West Hendon – Phase 4 Reserved Matters

PREPARED FOR:	Grady O'Brien (LBB)	Neil Wells (Quod)
COPY TO:	Eric Holroyd (Barratt London)	
	Paul Restall (CH2M)	
PREPARED BY:	Andy Mileham & Stuart Clark	
DATE:	April 06, 2017	
PROJECT NUMBER:	GWHPAS/AJM/TN02	
REVISION NO.:	First Issue	
APPROVED BY:	Paul Restall

This document is an addendum to the Transport Statement (TS) to address further comments on the transport impact of the development raised by consultees following review of the TS undertaken by London Borough of Barnet (LBB). This addendum report should be read alongside the TS.

Condition 98

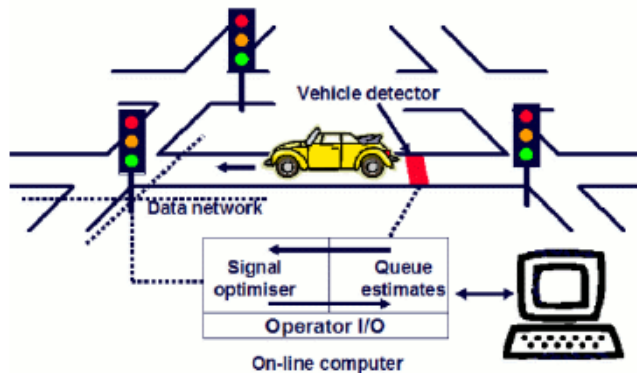
LBB Comment - The response to Condition 98 states: 'As there appears to be no overall increase in traffic it is not considered that any such changes are necessary to accommodate the additional traffic of the first units of Phase 4 in advance of the requirement for the major highway works.'

How many of the 1058 residential units permitted to be occupied prior to completion of the major highway works were actually being lived in at the time of the survey on the 6th June 2016?

CH2M Response – As stated within the original TA (Chapter 6); - at the end of Phase 3 the proposed redevelopment was modeled based on the predicted net increase of 497 residential units. The TA states that only minor modifications such as changes to the traffic signal timings would be required up to this threshold.

Using data supplied by the developer, a total of only 286 new units have been occupied to date.

Since the TA was written in 2013, TfL have implemented the program SCOOT (Split Cycle Offset Optimisation Technique) at all the key junctions along the Broadway. This program is an adaptive system that responds automatically to fluctuations in traffic flow through the use of on-street detectors embedded in the road (see image) therefore the SCOOT control would be expected to keep improving capacity by actively amending the signal timings until the major highway works are completed.

It should also be noted that from the observed flows collected in 2016 and referenced in the Reserved Matters TS that the general trend in the area has been a modest reduction in flows, hence the junctions should be working more effectively than what was originally reported in 2013.

There is also a budget allowance in the S106 for potential interim modifications to traffic signal timings if agreed between the developer and the highway authority. Which is subject to agreement with TfL, who would implement any changes.

The appropriateness of any such alterations is also likely to depend on the programmed implementation of the major works, which is yet to be determined. As there appears to be no overall increase in traffic it is not considered that any such changes are necessary to accommodate the additional traffic of the first units of Phase 4 in advance of the requirement for the major highway works.

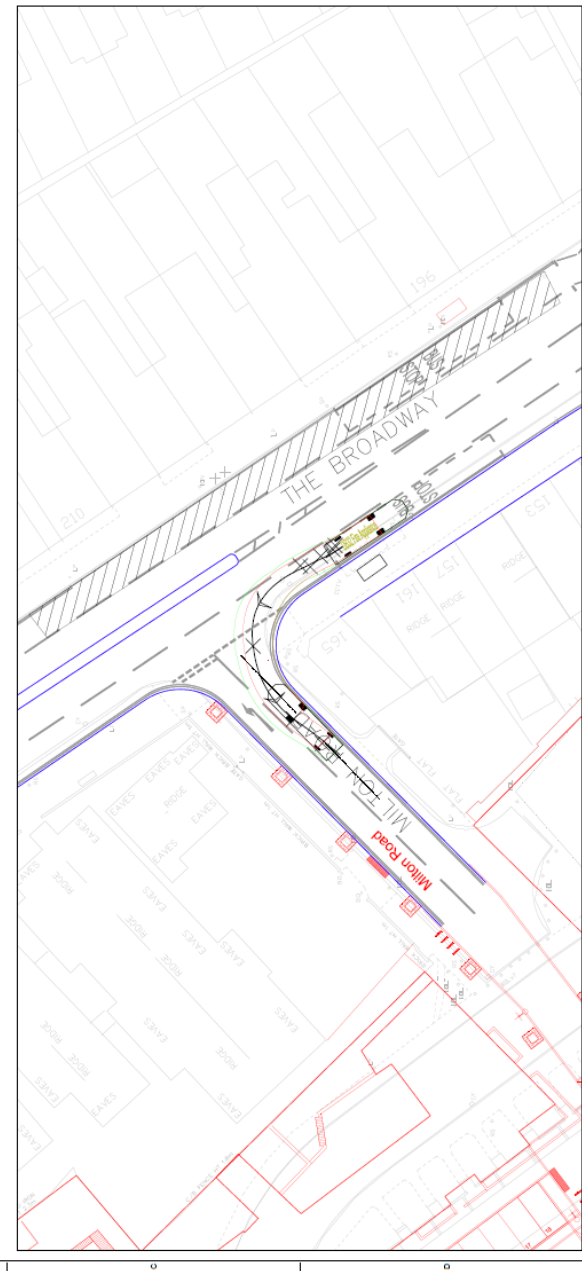
TS Appendix B Drg. No. DWGWHPAS-C-DWG-4412 – It looks like a refuse vehicle is to reverse onto a ramp and collect. Refuse will not collect from ramps and this will need to be a level surface.

TS Appendix B Drg. No DWGWHPAS-C-DWG-4413 – Milton Road access from A5 is very tight and may result in vehicle over-run and a maintenance issue.

CH2M can confirm that no refuse vehicles will reverse onto a ramp for collection. This drawing error and confirm that all refuse will be collected at street level. Currently no agreement has been made for the collection of bins from the A5. However, it is envisaged that collection along the A5 would continue in its current form.

With reference to the Milton Road access from the A5 being tight and that vehicles would over run the kerb and cause maintenance issues, a revised swept path analysis has now been undertaken using the standard practice vehicles such as a fire tender and is provided for reference as GWHPAS-C-SKT-MHW100 in [Appendix C](#).

It should be noted that Milton Road forms the minor secondary access to the site with Ravenstone Road being designed as the main access route from both the A5 and the site. Therefore it is envisaged that certain vehicles of a certain size would use this to gain access instead. It is expressed that a car transporter is required to turn from the A5 into Garrick Road/Wilberforce Road/Herbert Road between the North Circular and West Hendon Broadway. A swept path assessment has been undertaken and is provided for reference on drawing GWHPAS-C-SKT-MHW101 and is located within [Appendix D](#).

By widening the junction Radii of Herbert Rd/Broadway to 8m the tracking demonstrates that a car transporter can undertake the required turning movements successfully if required. It is recommended that the Toyota garage is consulted during detailed design to establish the necessary design vehicle and agreed servicing route prior to finalising the highway design.
